SAN LUIS OBISPO COUNTY
DEPARTMENT OF PUBLIC WORKS
Paavo Ogren, Director

November 14, 2013

ADDENDUM NO. 4 TO
LOS OSOS WASTEWATER PROJECT
LOS OSOS WATER RECYCLING FACILITY
LOS OSOS, CA
CONTRACT NO. 300448.08.02

Certain revisions are hereby incorporated into the Bidding Documents for the subject project. These revisions are as follows:

SAN LUIS OBISPO COUNTY
LOS OSOS WATER RECYCLING FACILITY PROJECT
ELECTRICAL
SLUDGE STORAGE TANKS
POWER & CONTROL PLAN

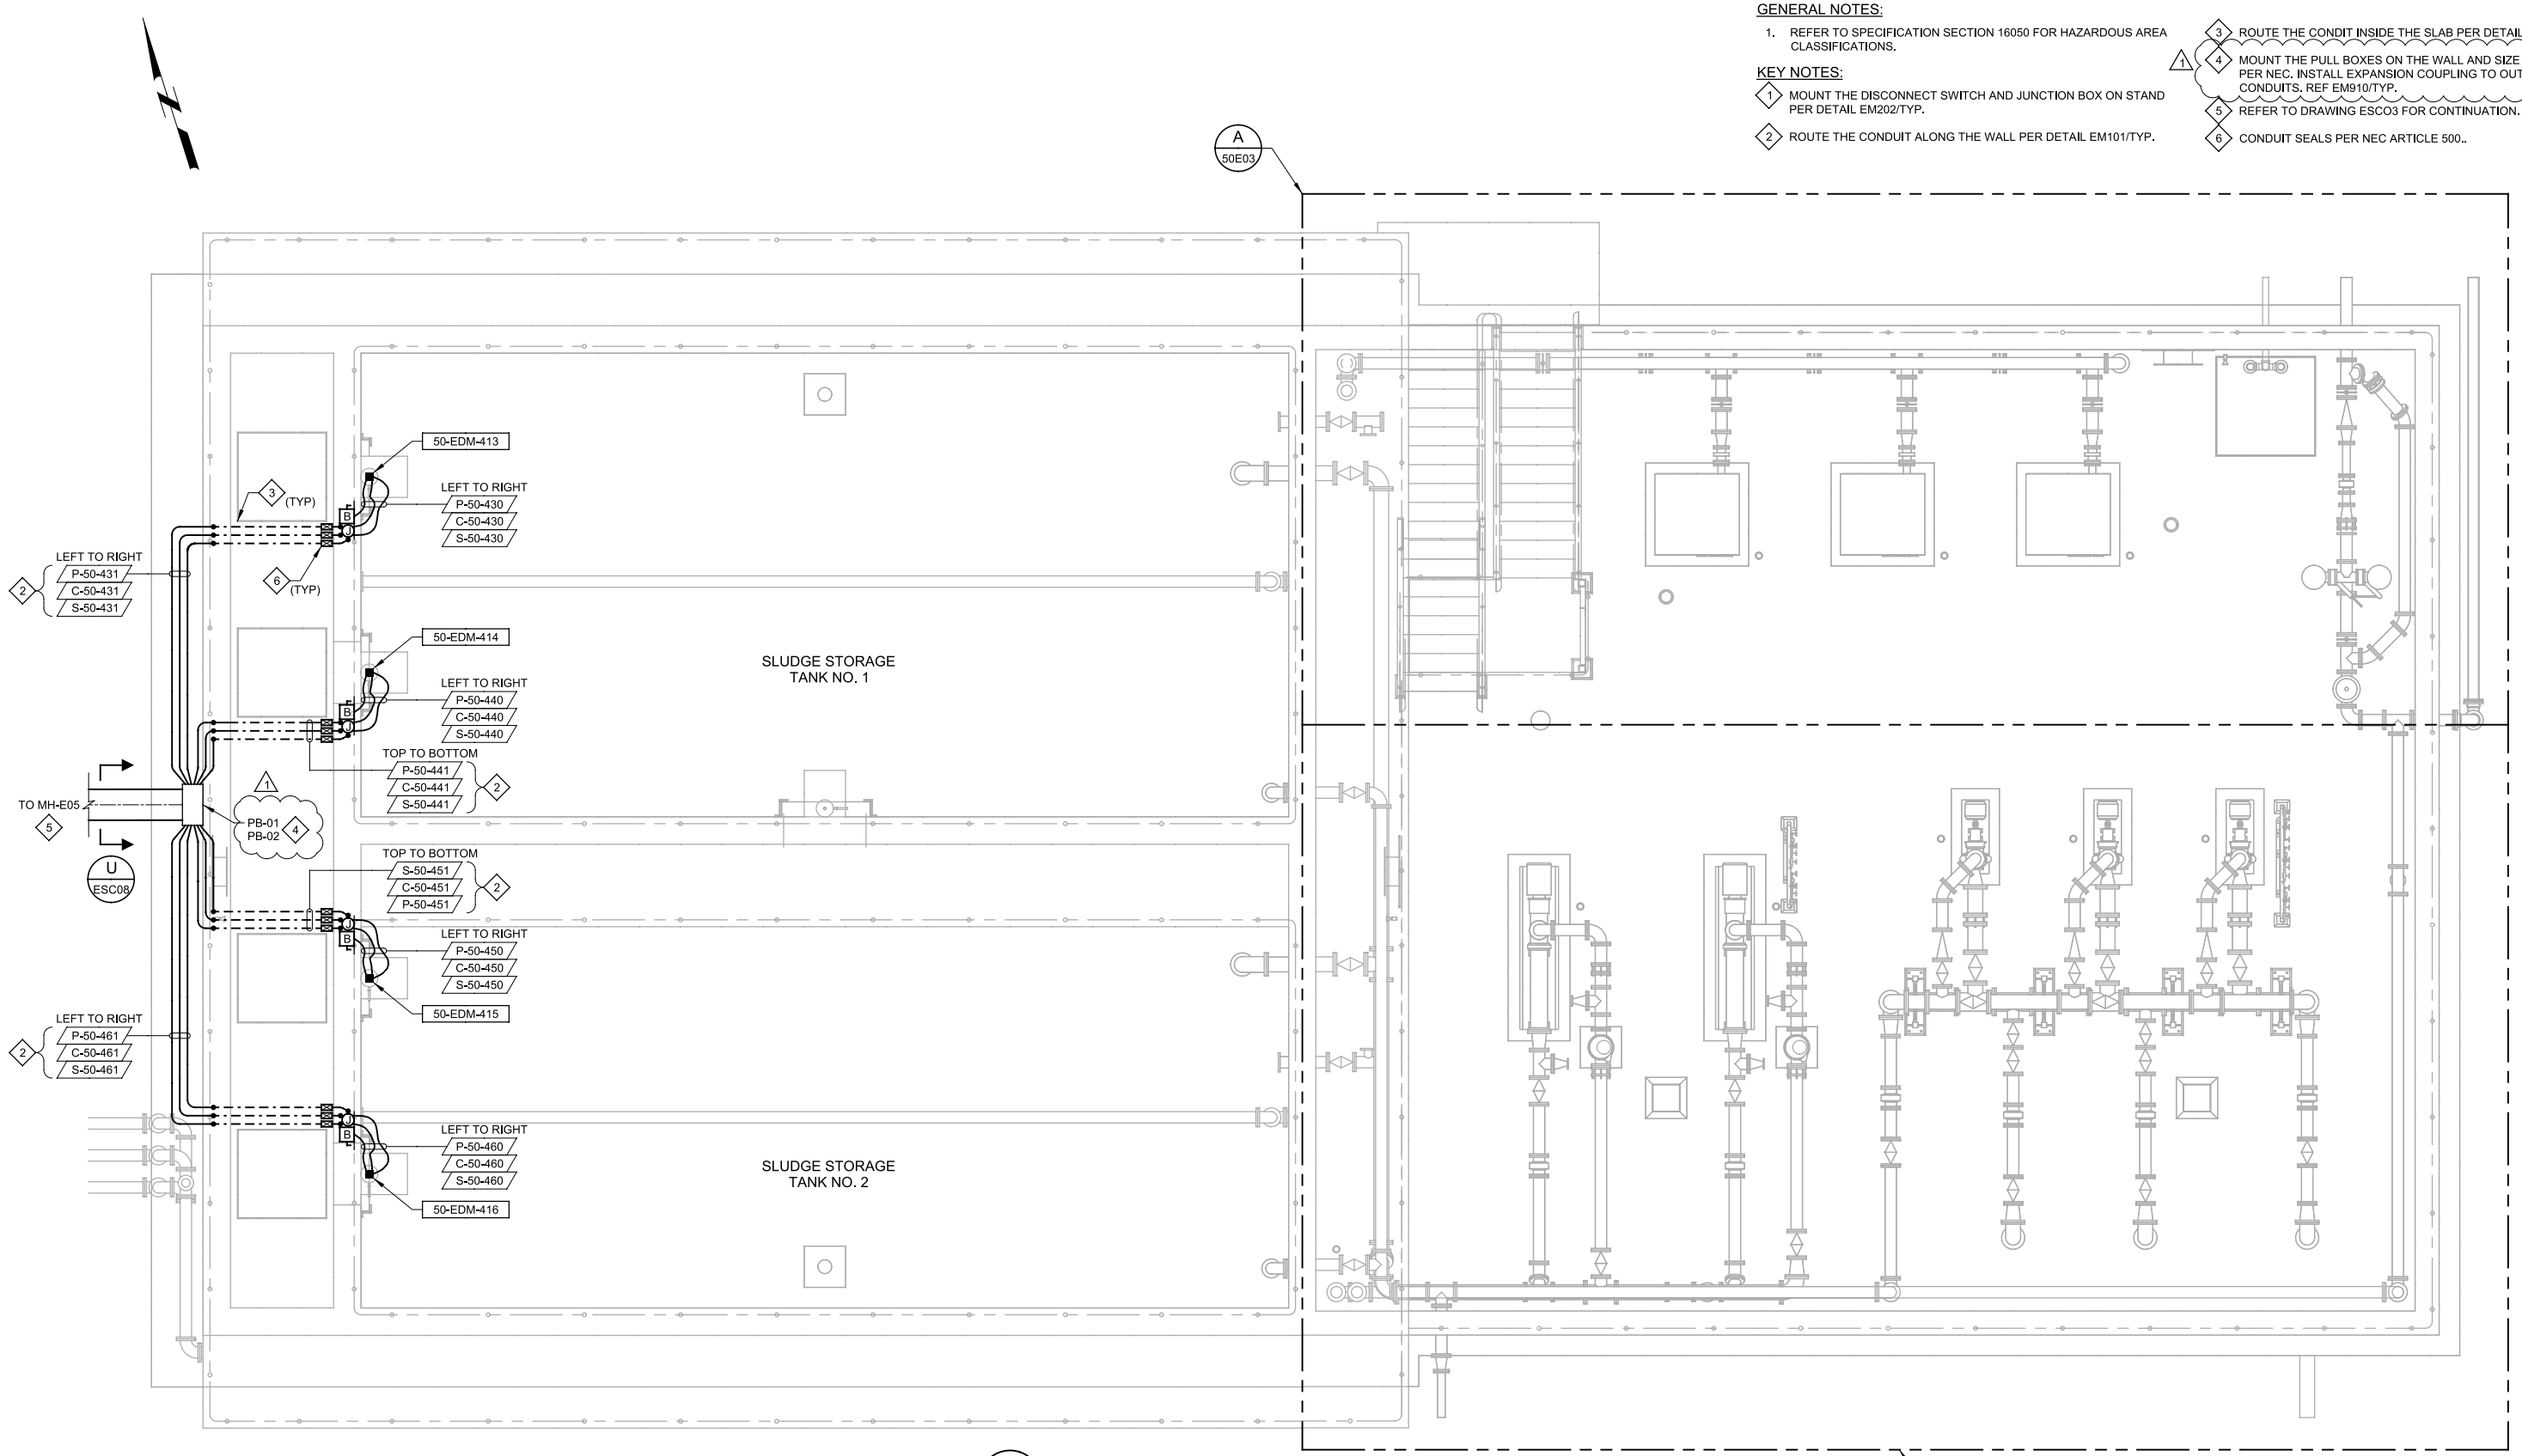
REV	DATE	BY	DESCRIPTION
1	11/2013	IV	ADDENDUM NO. 4: CONDUITS SHIFTED DOWN. NO CONDUITS ADDED OR DELETED.
